# Studebaker

# SERVICE BULLETIN

NO. 240

1950

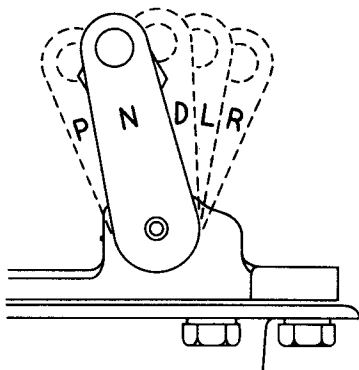
1. Remove the bell crank to transmission rod from the selector valve lever and the bell crank lever to which the rod is attached.
2. To place the transmission in the Neutral range, move the selector valve lever on the transmission as far forward as it will go. In this position the transmission is in the

Park range. Then move the selector valve lever back one detent. In this position the selector valve lever will be in direct line with the forward band adjusting screw located immediately behind it on the transmission. (See opposite.) With the selector

### AUTOMATIC TRANSMISSION PULLBACK SPRING - 17A

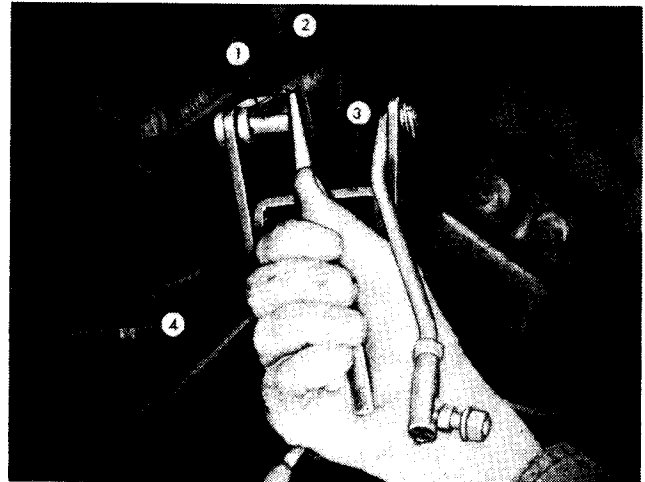
As shown in the illustration above, there is only one pullback spring to be disconnected when removing the torque converter assembly.

The last line on page 43 of the Automatic Transmission Preliminary Shop Manual should read, therefore, "the pullback spring (4)."
